## CALVERT CLIFFS NUCLEAR POWER PLANT UNIT NO. 1

## AMENDMENT TO FACILITY OPERATING LICENSE

Amendment No. 78 License No. DPR-53

## ATTACHMENT TO LICENSE AMENDMENT NO. 78

Steam Generator Pressure vs. Auxiliary Feedwater Flow Figure 3.7-1,

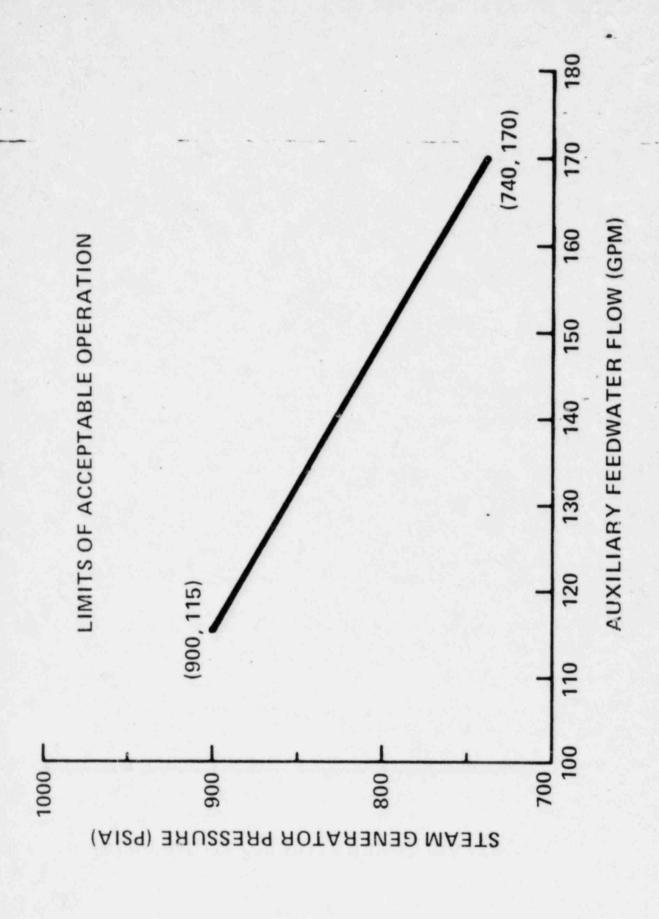
- Verifying, upon automatic initiation of auxiliary feedwater, a flow within the acceptable operating limits of Figure 3.7-1, Steam Generator Pressure Versus Auxiliary Feedwater Flow.
- \*d. Upon repositioning of 1/2-CV-4511 and/or 1/2-CV-4512 the valve shall be realigned to provide flow consistent with Figure 3.7-1.

A minimum flow of 88 gpm and a maximum flow of 142 gpm to each steam generator when automatically initiating AFW flow for a steam generator pressure of 900 psia is required to ensure sufficient time for operator action to maintain an adequate heat sink for the reactor. A nominal flow setting of 115 gpm at 900 psia is used to account for instrument error and system flow repeatability. Figure 3.7-1 shows the allowable flow as a function of steam generator pressure.
